ORIGINATION FORM

Proposed Revisions to a Standard Plans Index

Index Number: 455-160
Sheet Number (s): 1
Index Title: 60" Prestressed CFRP & SS Concrete
Cylinder Pile

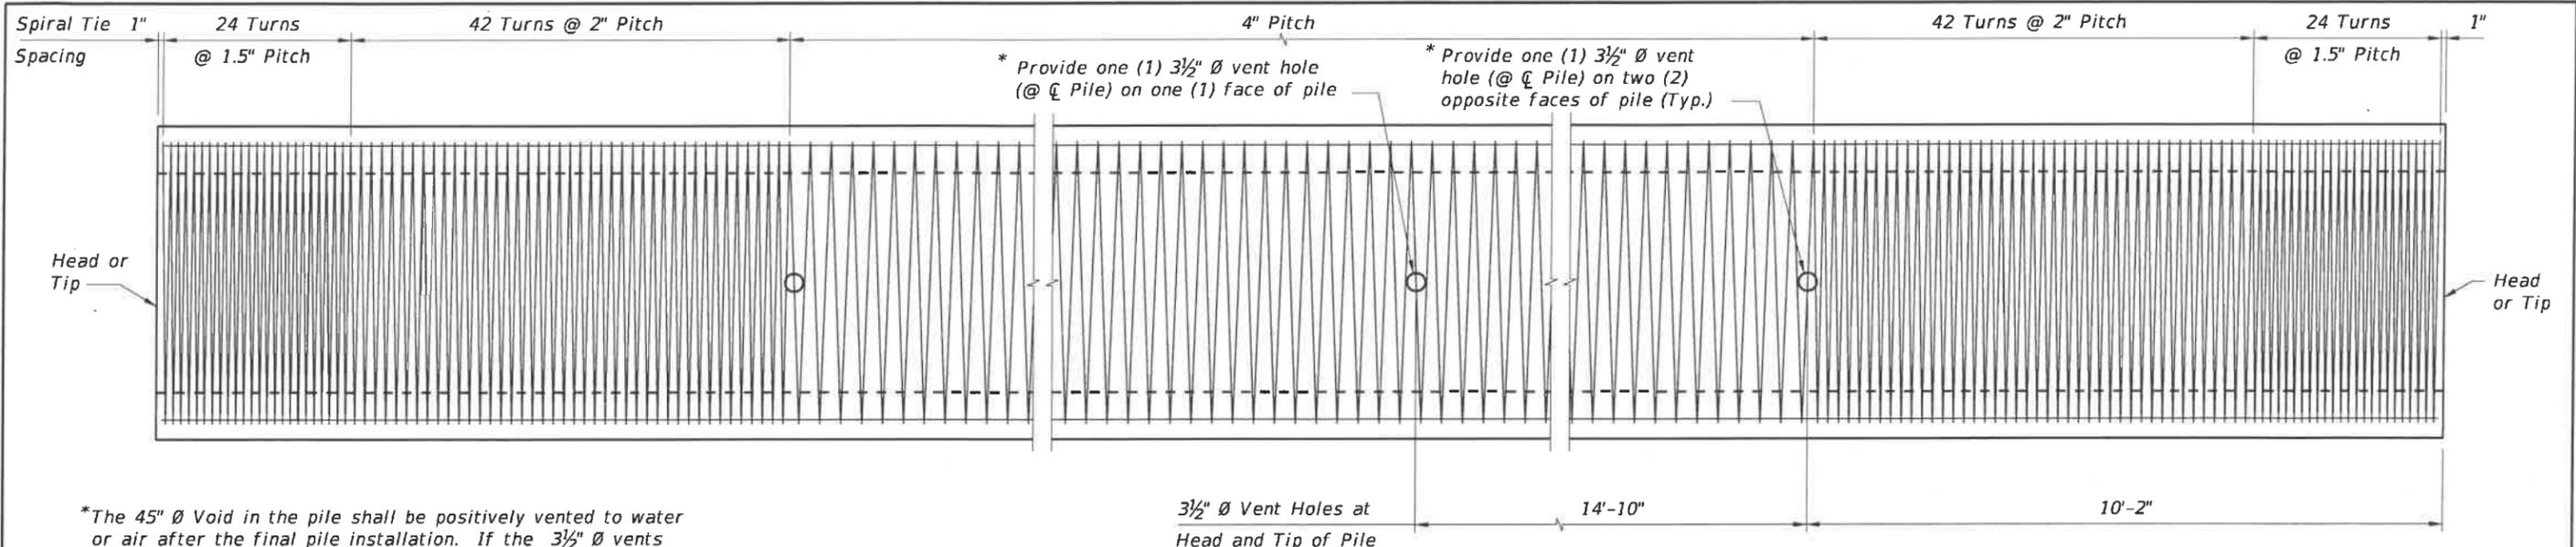
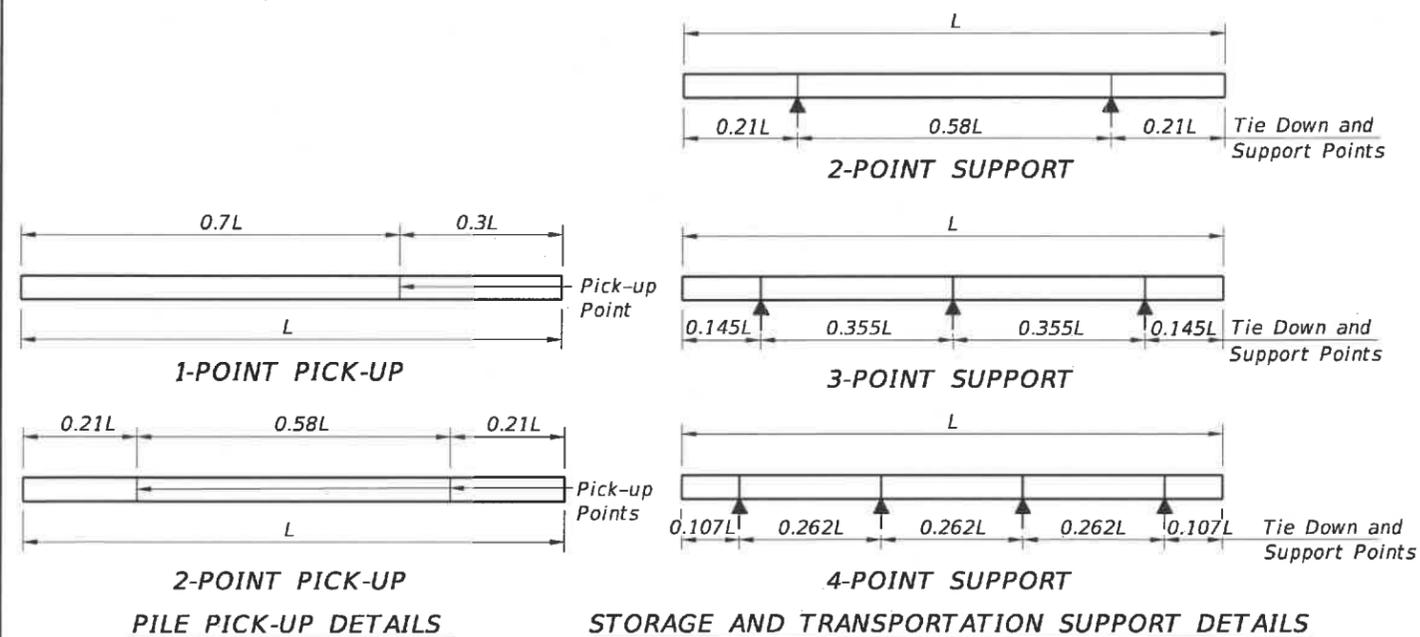
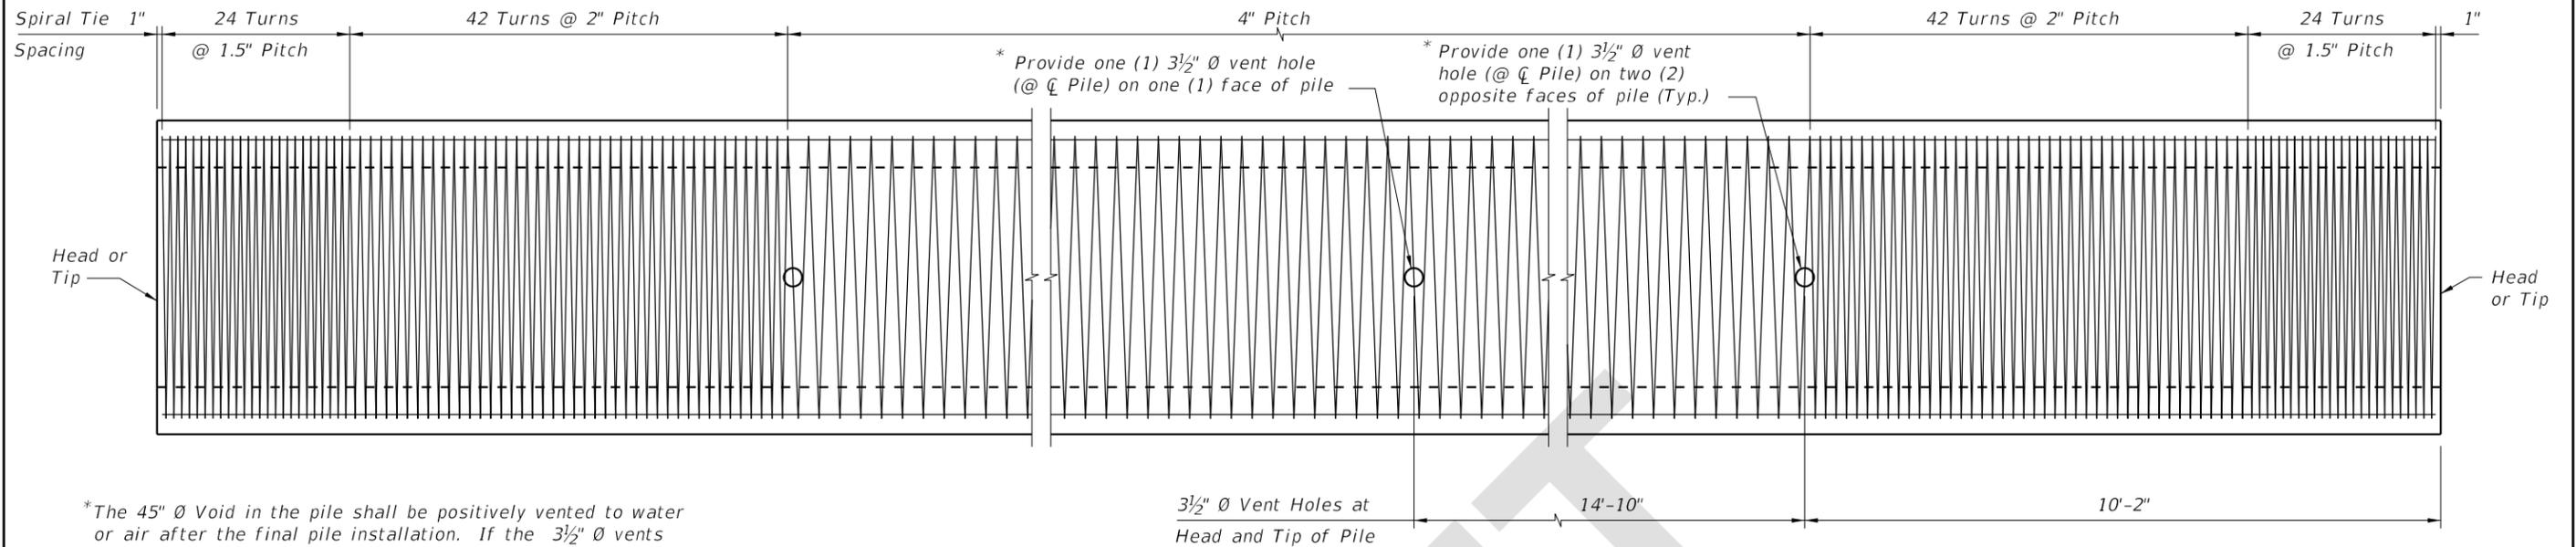
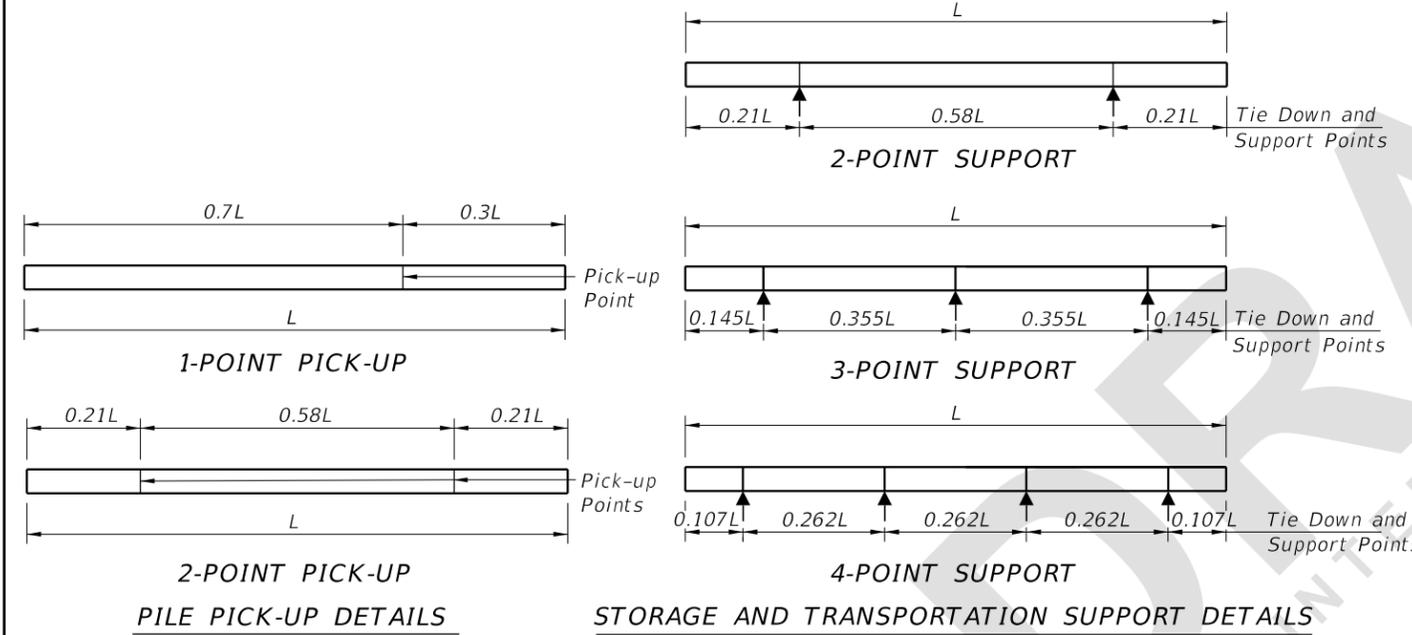
Changed Class V (Special) concrete to Class V.

- Work this Index with the Pile Data Table in the Structures Plans.
- Concrete:
 - Piles: Class V (Special)
 - Splice Collar: Class IV
 - See "GENERAL NOTES" in the Structures Plans for locations where the use of Highly Reactive Pozzolans is required.

1. Work this Index with the Pile Data Table in the Structures Plans.
2. Concrete:
 - A. Piles: Class V
 - B. Splice Collar: Class IV
 - C. See "GENERAL NOTES" in the Structures Plans for locations where the use of Highly Reactive Pozzolans is required.
